Response to EMCa Report

TransGrid submitted its revenue proposal for the 2014/15 to 2018/19 regulatory control period to the AER on 2 June 2014. The revenue proposal sets out the revenue and expenditure TransGrid requires to provide transmission services for an upcoming period.

As part of the AER’s review of TransGrid’s revenue proposal, the AER engaged EMCa as technical consultants to provide advice on TransGrid’s proposed replacement capital expenditure. EMCa has provided its advice in a report, *Review of Proposed Replacement Capex in TransGrid Revenue Proposal 2014-2019*, October 2014 (EMCa report).

Figure 2
Transmission Line Outages

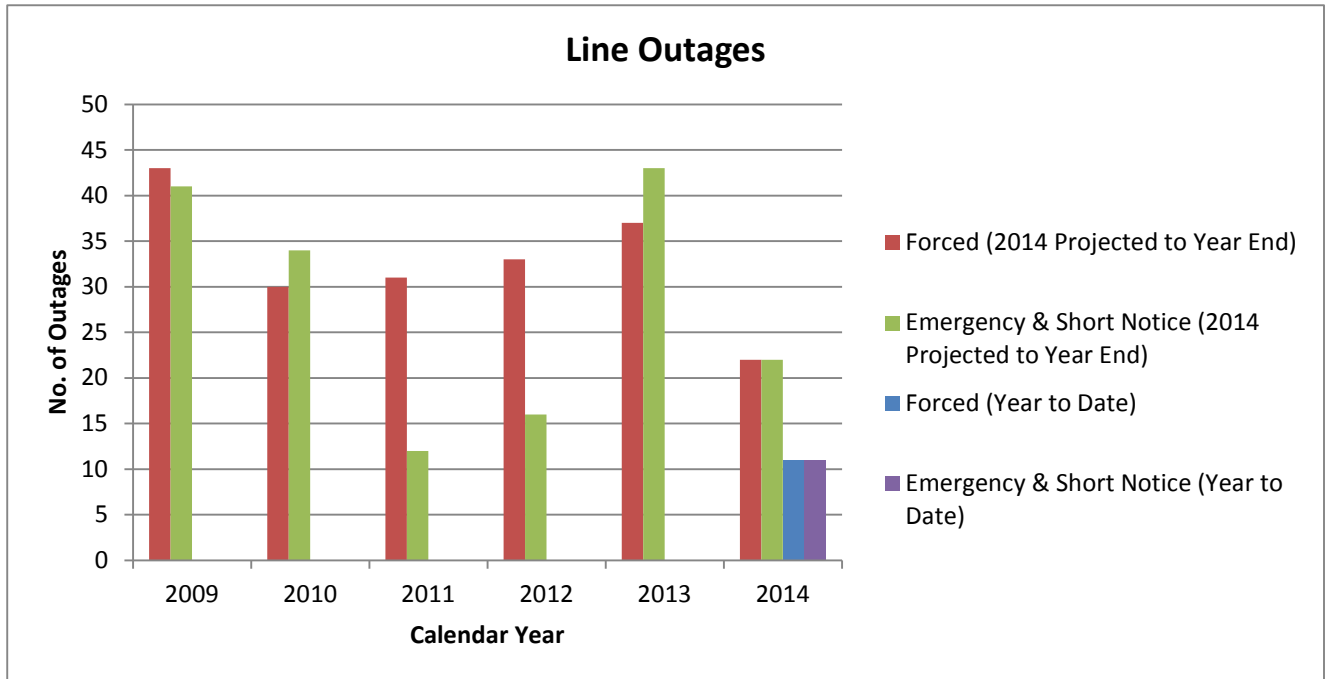
43. The network "observable failure risk" is reported at the corporate level and has been assessed as 'Medium' with a stable trend. Whilst this risk is not identified as a driver of expenditure by TransGrid, we would have expected to see a greater correlation between asset class risks and project level risks to this corporate risk. We also note that the network performance metrics of system minutes, line outages, transformer outages and reactive plant outages have been relatively stable or improving since 2009. The risk and performance trends do not independently signal the need for a major change in asset management focus.

The trends of outages of transmission lines, transformers and reactive plant that were in the information provided to EMCa are shown in Figures 2, 3 and 4. These indicators align with the definitions in the AER's

These long term trends in performance indicators show that:

- the additional replacement expenditure in the 2009/10 to 2013/14 period compared with the 2004/05 to 2008/09 period was prudent and appropriate to effectively control the key risks and hazards associated with the assets;
- the long term trend due to the condition of the assets (as set out the condition assessments presented as part of the revenue reset and comparison of the values of risk of the portfolio in Section 5.5.2 of the revised revenue proposal) indicates that additional expenditure is required in the 2014/15 to 2017/18 period; and
- the expenditure for the next period has been estimated using the similar principles, and approaches to risk and condition assessment methodologies as the last period. The trends above show that TransGrid has been prudently spending to effectively manage its key performance indicators and risks over the last two regulatory control periods.

Figure 8
Network Investment Documentation

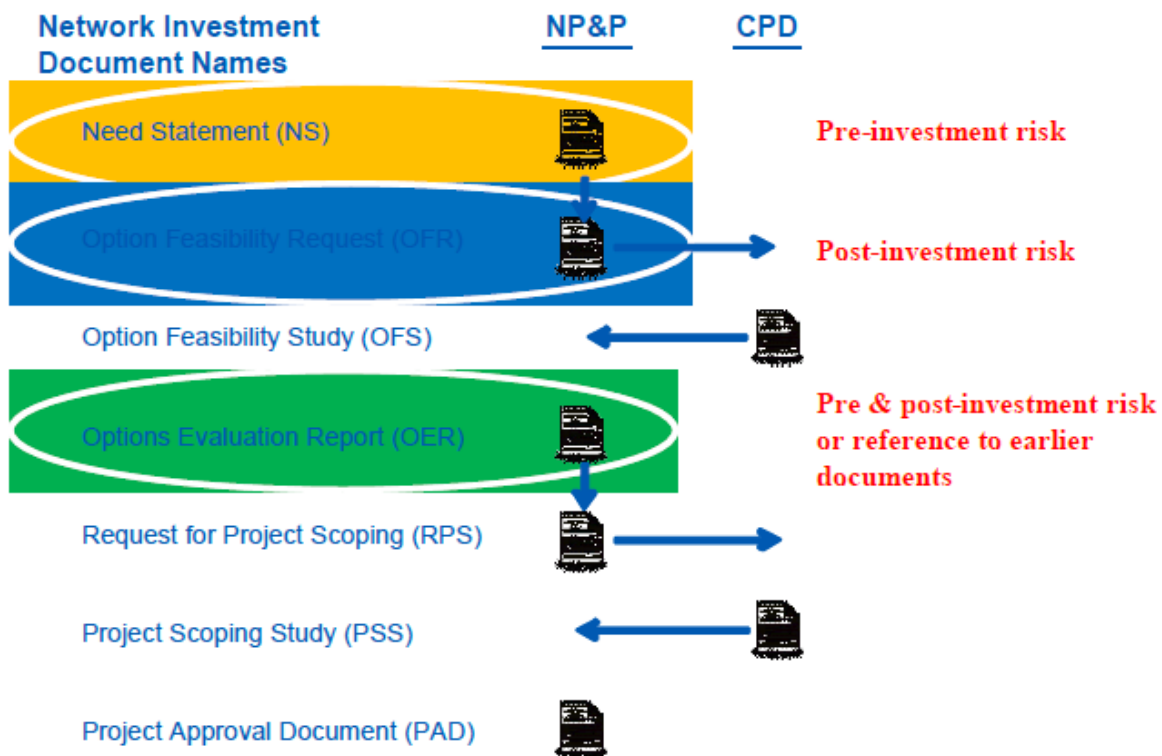
58. TransGrid stated that they have recently updated their investment planning process and capital project documentation, including options analysis. We nevertheless found insufficient examples of sub-option investigation, feasibility or development to mitigate identified risks. Rather, we found that the selected options were very broad in nature and sought to lower the identified risk to “green” rather than to an acceptable level with consideration of the economic cost as required by the TransGrid risk management framework. Figure 4 shows the residual risk after the completion of the projects with 50% being Low and 50% at the Medium level. However, in the project documentation provided for substation renewal projects, we found no assessments of the residual risk costs in the options. It is not clear how or when these residual risks were determined.

EMCa has contradicted itself in this paragraph. As it has noted, Figure 4 in its report shows that only half of the projects have their residual risk moved to the green (low risk) level. Those projects remaining in the yellow (medium risk) range can still have significant risk costs associated with them. It is unclear how EMCa have formed the opinion that the selected options are biased towards moving the risk to the green level.

TransGrid dispute EMCa’s assertions that there is no residual risk determined for each option and that it is not clear how the residual risks are determined. Residual risk is determined using the same methodology as highlighted in the NIRAM and documented in the relevant network investment document, as shown in Figure 8.
